March 2005

## Bourns® Trimpot® Division Announces 3006P-7 Product Update

*Tan Epoxy Compared to Traditional Blue Epoxy*

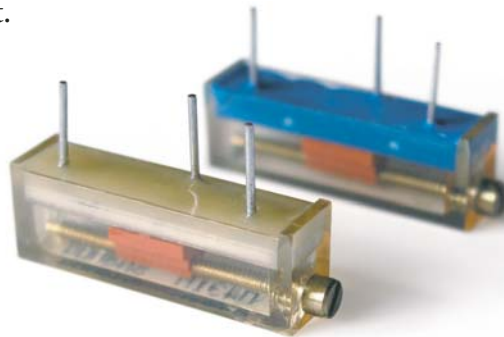
Bourns is pleased to announce a product update to the Model 3006P-7. Effective April 18, 2005 with date code 516M we will phase-in a new UV curable epoxy. The new epoxy is tan in color, resistant to moisture and withstands the increasingly severe temperature excursions required for RoHS compliant product.
